**ARPANSA Regulatory Assessment of the Replacement Reactor Construction Application**

18 July 2001- Reactive Review Questions and Issues

PSAR Chapter 5 The Reactor

**APPENDIX 1: INFORMATION FOR QUESTION REFERENCE 5.33**

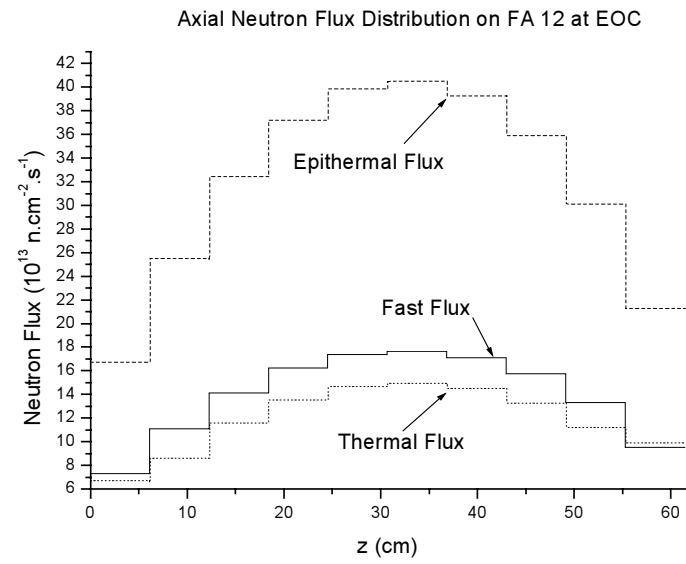
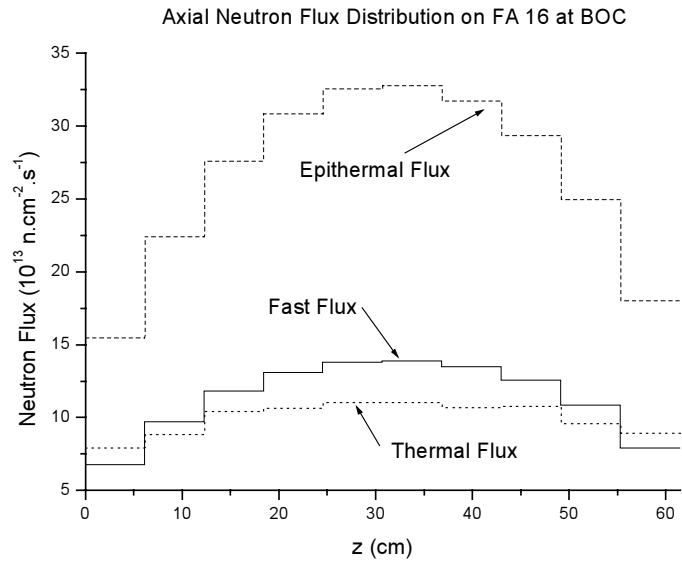
| Question Reference | Section number and name   | Topic for clarification   | ARPANSA Comment, Issue or Question  |
|--------------------|---|---|---|
| 5.33.              | 5.7.5.2 Neutron Flux and Power distribution.<br>Figures 5.7/5-1 – 5.7/9-3 | Neutron fluxes at BOC and EOC   | Please provide information on neutron fluxes along most rated FA, at the top, bottom and midplane should be provided both for BOC and EOC in graphical form.  |

| Question Reference | Section number and name   | Topic for clarification   | ARPANSA Comment, Issue or Question  |
|--------------------|---|---|---|
|                    |   |   | Response: Information is provided in Appendix 1.  |

Flux distributions is provided for the FAs having the maximum power density at BOC and EOC namely, FA 16 and FA 12 respectively. The values presented in the tables and the graphics are the average neutron fluxes. Average neutron fluxes are computed in the volumes that results from the division of the FA active length in 10 equal parts. Layer 1 corresponds to the upper part of the FA and layer 10 to the lower part of the FA.
